UNITED STATES PATENT AND TRADEMARK OFFICE

APPLICATION NO.	FILING DATE	FIRST NAMED INVENTOR	ATTORNEY DOCKET NO.	CONFIRMATION NO.
10/086,908	02/28/2002	Will G. Fetherolf	10015361-1	1658

Office Action Summary

DETAILED ACTION***Claim Rejections - 35 USC § 103***

FIG. 2

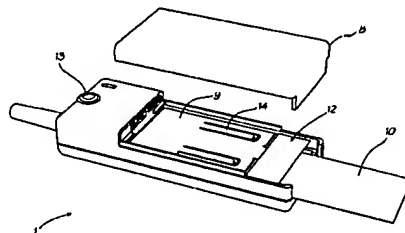
Silverbrook et al discloses:

- {claims 6 and 16} print media processing engine (figure 2, reference 12) where the depth is smaller than the height and the width (figure 2, reference 12)

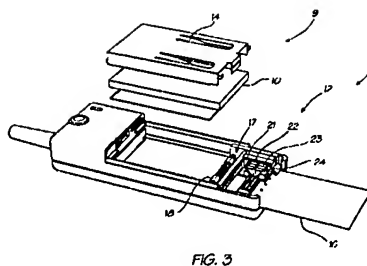
- {claims 11 and 18} media receiver orders a plurality of media (figure 3, reference 9)

received from the media output by gravity force (figure 4, reference 10, 17; inherent because media exits in downward direction and gravity has downward pull)
